**STAFF RECOMMENDATION**  
**1515 Beechwood Avenue**  
**February 15, 2012**

**Application:** Demolition and Infill  
**District:** Belmont-Hillsboro Neighborhood Conservation Zoning Overlay  
**Council District:** 18  
**Map and Parcel Number:** 11704002600  
**Applicant:** Tradition Homes/ Daniel Green and Brian Layton  
**Project Lead:** Melissa Baldock, melissa.baldock@nashville.com

<p><b>Description of Project:</b> Applicant proposes to demolish a non-contributing building and construct a one-and-a-half story single-family dwelling with a detached rear accessory building.</p> <p><b>Recommendation Summary:</b> Staff recommends approval of demolition of the non-contributing building and construction of the infill building and accessory structure with the conditions that:</p> <ol style="list-style-type: none"> <li>1. Staff review and approve a brick sample, metal sample, windows and doors, porch details, asphalt shingle color, shutters and trim for both structures; and</li> <li>2. HVAC be located at the rear of the home or on the side, beyond the mid-point of the house.</li> </ol> <p>With these conditions, staff finds that the project meets Section II.B.1. and III.B.2. of the <

AS-BUILT SURVEY  
FOR  
**1515 BEECHWOOD AVENUE**

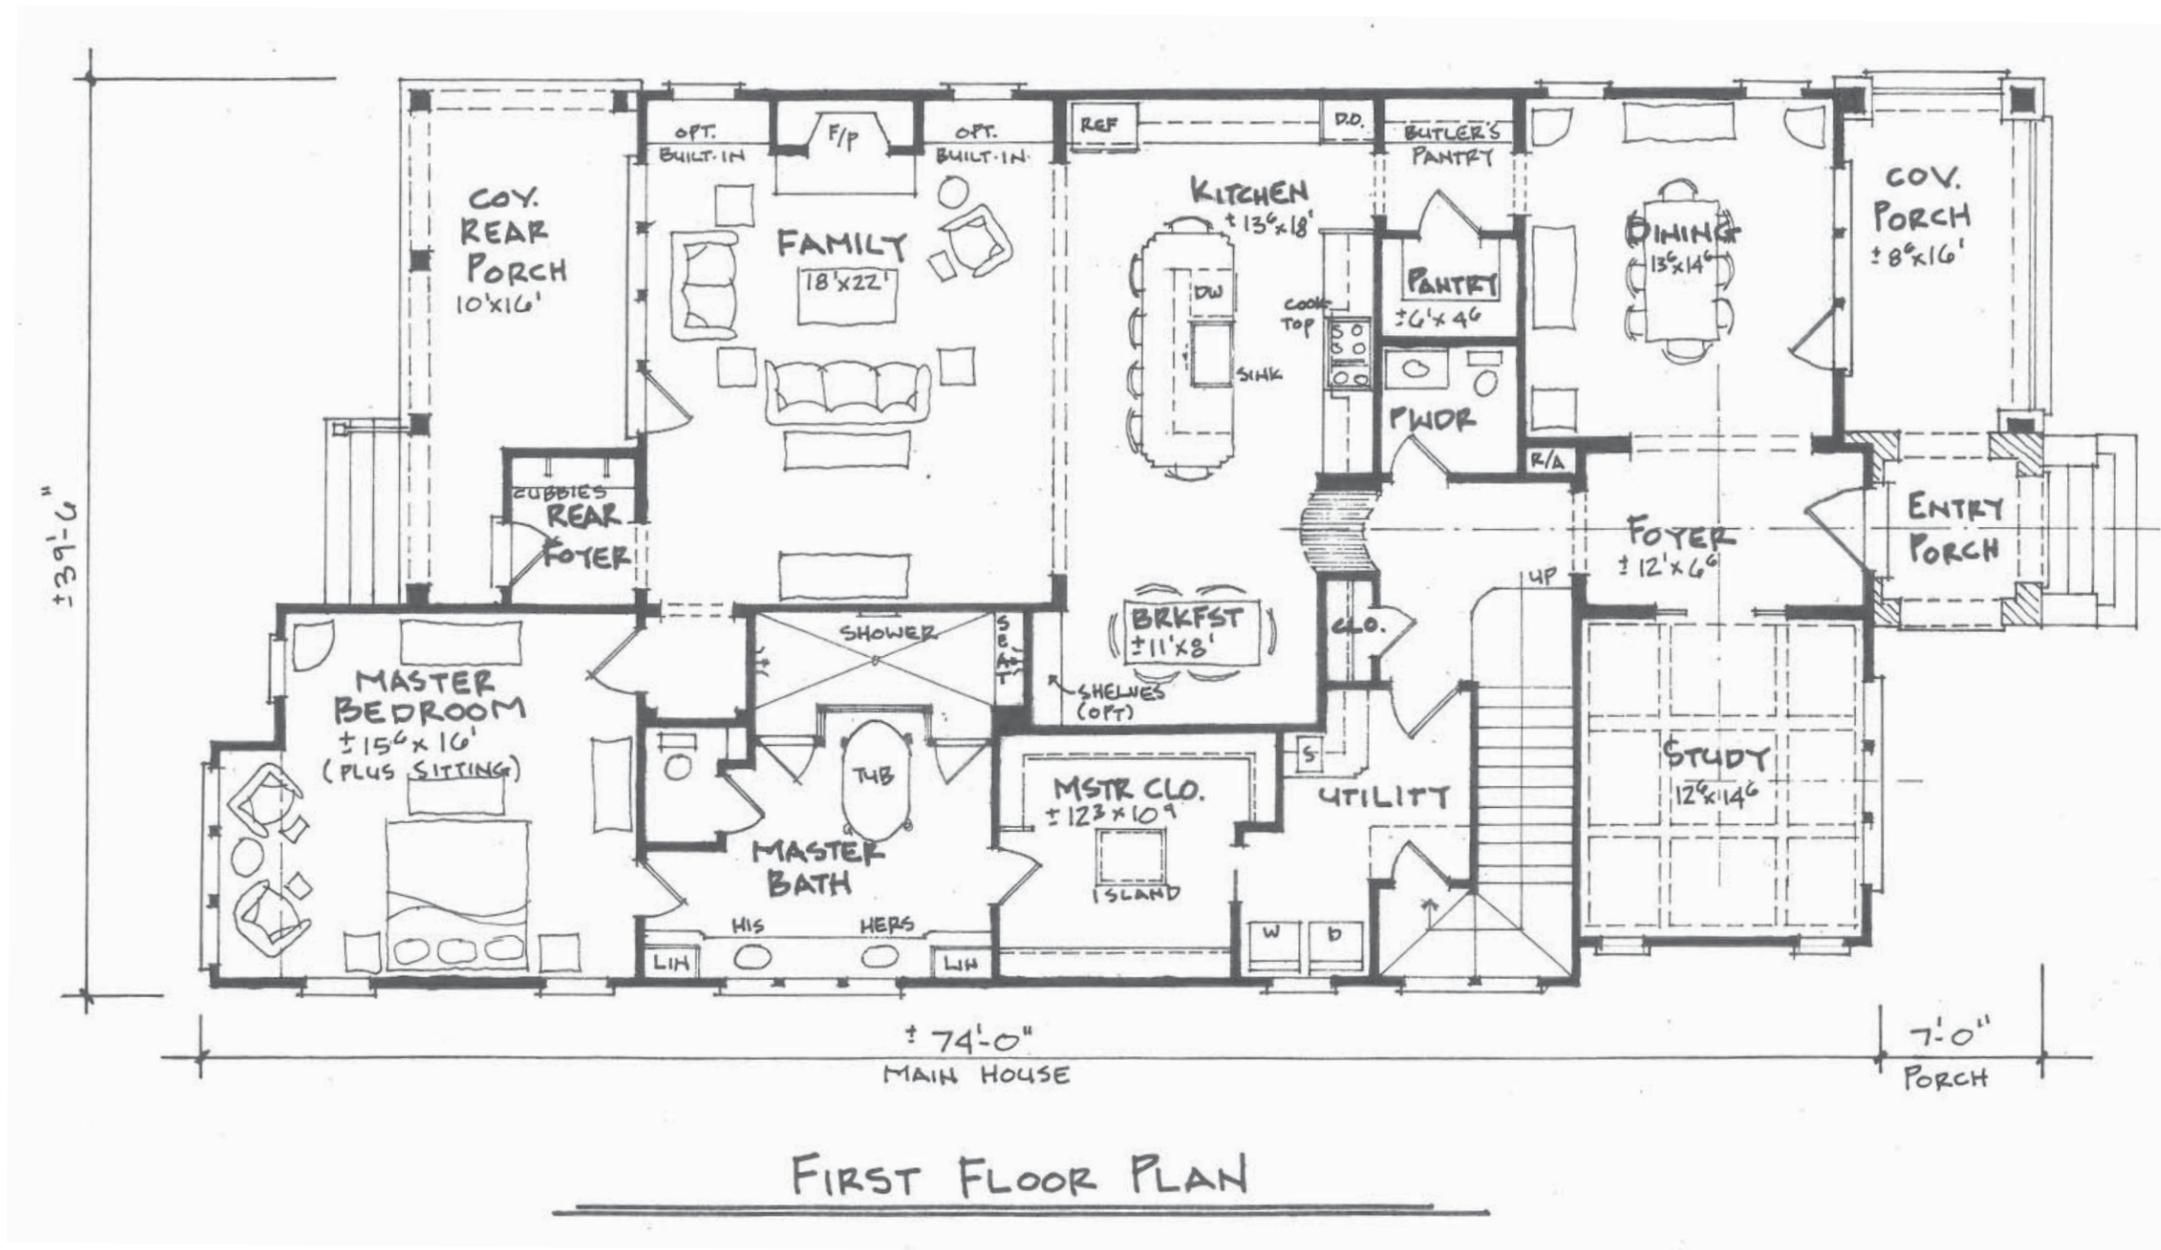
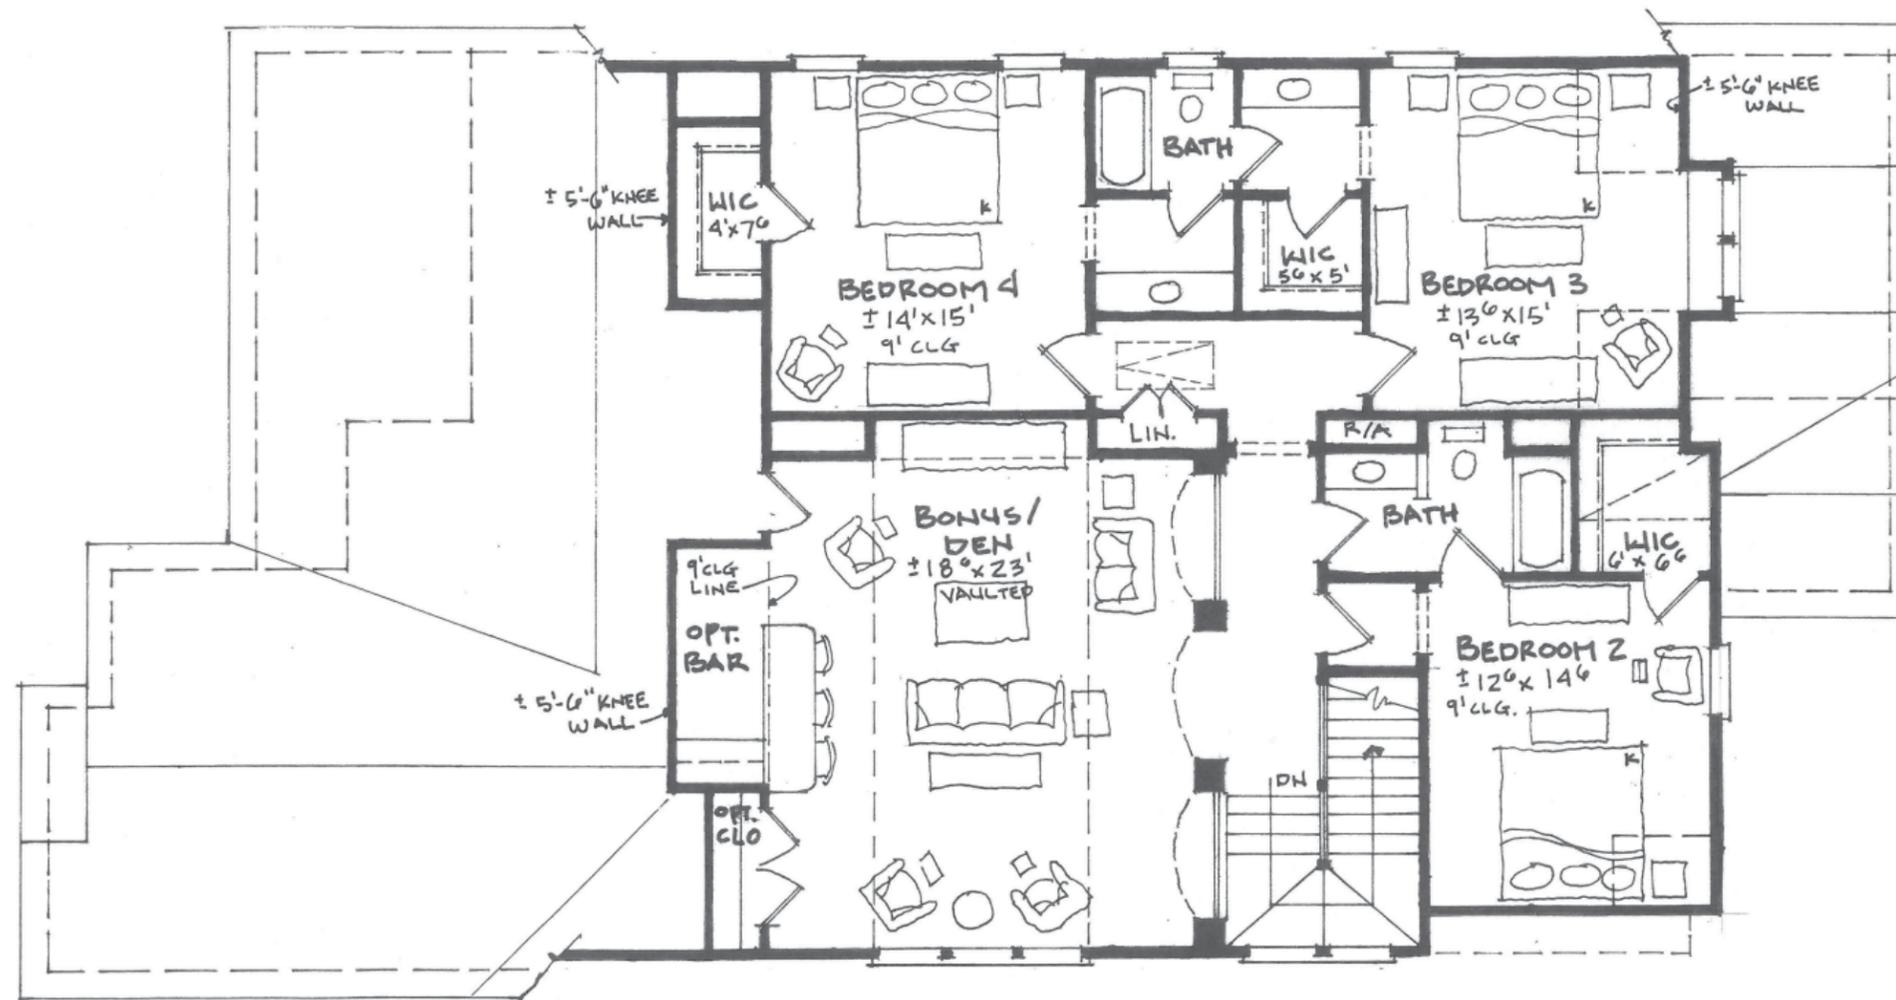
Location and Setback: The proposal meets all bulk zoning setback requirements. The primary building is centered on the lot similar to other historic buildings found in the district. The front porch of the house will be in line with the front porch of its neighbor to the left. The house will be a minimum of five feet (5') from the side property lines. The accessory structure will be in the rear of the lot and will be a minimum of three feet (3') from the left side property line, ten feet (10') from the rear property line, and more than twenty feet (20') from the right side property line. The accessory structure will be accessed from the rear alley and will have garage doors facing the alley, as is typical for accessory structures in the neighborhood.

FRONT ELEVATION

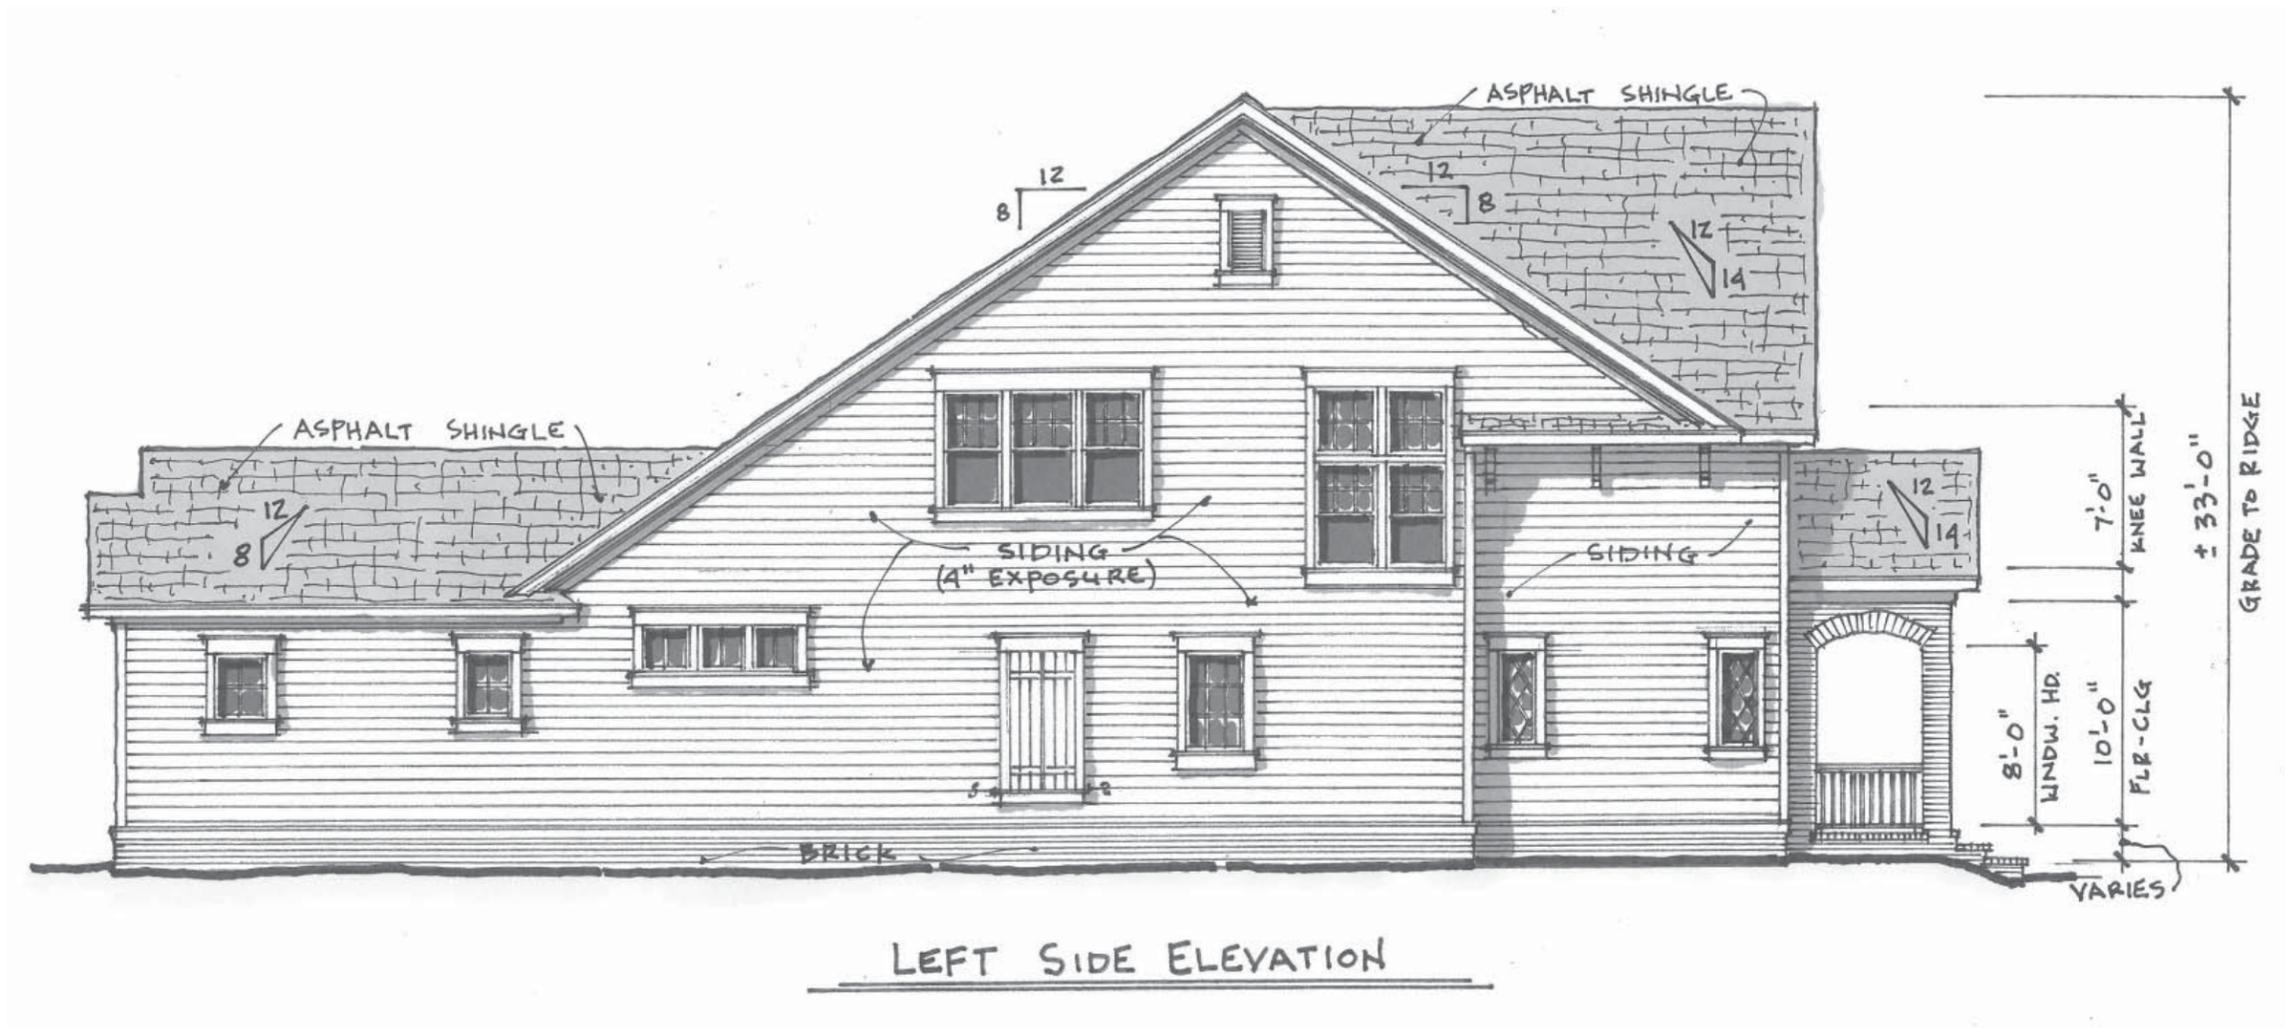
Height & Scale: The proposed dwelling is a one-and-a-half story house that is thirty-three feet (33') tall from grade to ridge. The majority of historic homes in the immediate context that are oriented towards Beechwood are also one-and-a-half stories and range in height from twenty-one to thirty-five feet (21' to 35') tall. The neighboring houses on Belmont Boulevard, however, are taller and rise to a height of two to two-and-a-half stories. The house to the right of the site faces Belmont and is about thirty-seven feet (37') tall. The house to the left of the site was approved by the Commission in January 2011 and is approximately thirty-four feet (34') tall. The foundation is approximately

The maximum width of the building is thirty nine feet, six inches (39' 6"), but at the front of the house, the width is less and is approximately thirty-seven feet, six inches (37' 6"). This width is in keeping with the context on this block of Beechwood, which has widths in the range of approximately twenty-five and forty feet (25'-40'). The infill house to the left, which the Commission approved in 2011, is forty feet (40') wide. The front porch is between six and eight feet (6'-8') deep, and there is a change in material between the body of the building and the foundation.

Roof: The primary building has a side-gable roof with a pitch of eight-twelve (8/12), and the front porch has a pitch of fourteen-twelve (14/12). The side gable accessory structure has a twelve-twelve (12/12) pitch with a four-twelve (4/12) pitched wall dormer. The roof shapes and pitches are found on historic buildings throughout the district and so meet Sections II.B.1.e. and II.B.1.i. of the *Belmont-Hillsboro Neighborhood Conservation Zoning Overlay Handbook and Design Guidelines*.

Orientation: The primary building has a partial width front porch and centered primary entrance facing Beechwood Avenue, as do most of the buildings on this block, with the exception of those at the corner of Belmont and Beechwood, which face Belmont Boulevard. Vehicular access is from the alley. There is no existing or proposed curb cut or driveway. The orientation meets Sections II.B.1.f and II.B.1.i. of the *Belmont-Hillsboro Neighborhood Conservation Zoning Overlay Handbook and Design Guidelines*.

Proportion and Rhythm of Openings: The windows of both structures are approximately twice as tall as they are wide and so meet the historic ratio of windows in the neighborhood. There is no area greater than thirteen linear feet without an opening. Staff finds that the window proportions and rhythm of openings meets section II.B.1.g. of the *Belmont-Hillsboro Neighborhood Conservation Zoning Overlay Handbook and Design Guidelines*.

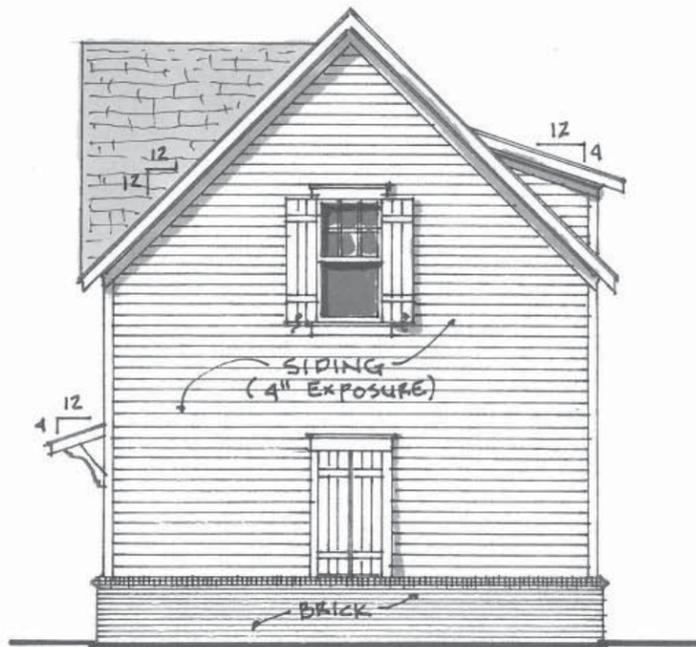
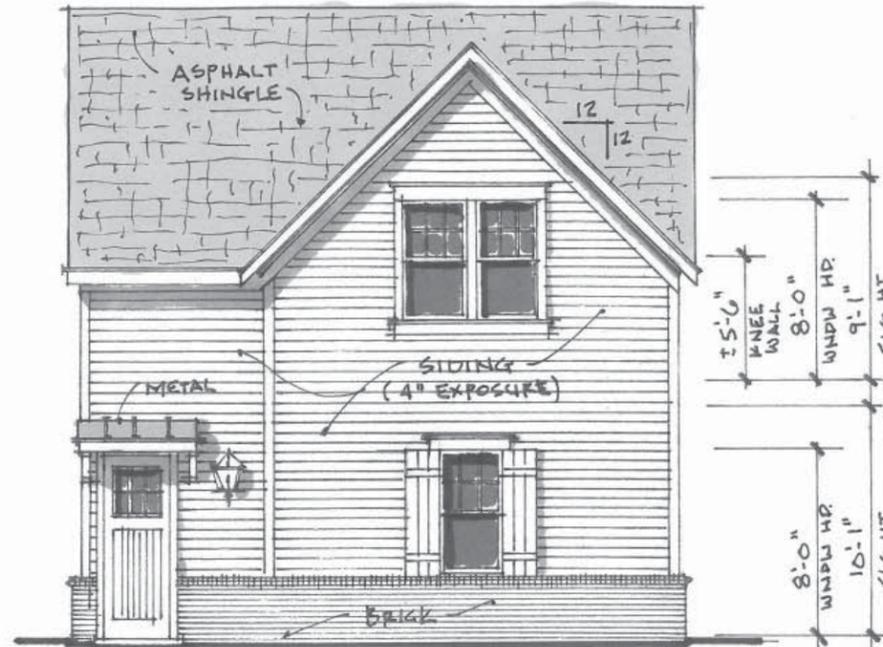
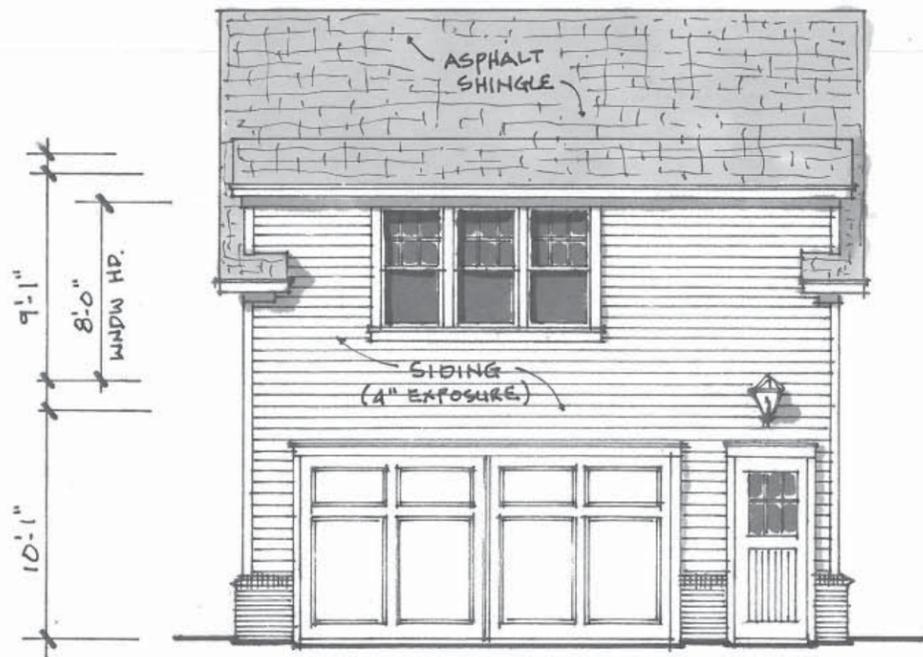
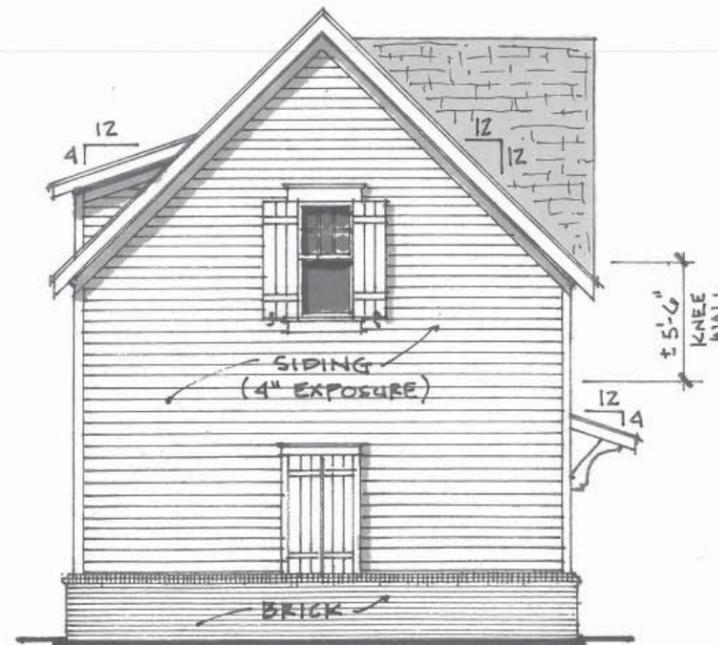
The accessory building's six hundred and seven foot and six inch (607'6") footprint and twenty-eight foot (28') height keeps it subordinate to the thirty-three foot (33') tall primary building.

Outbuilding: The design and materials of the outbuilding are similar to those found on the house, and its height, scale, location, roof form, materials, and orientation meet section II.B.1.i. of the *Belmont-Hillsboro Neighborhood Conservation Zoning Overlay Handbook and Design Guidelines*.
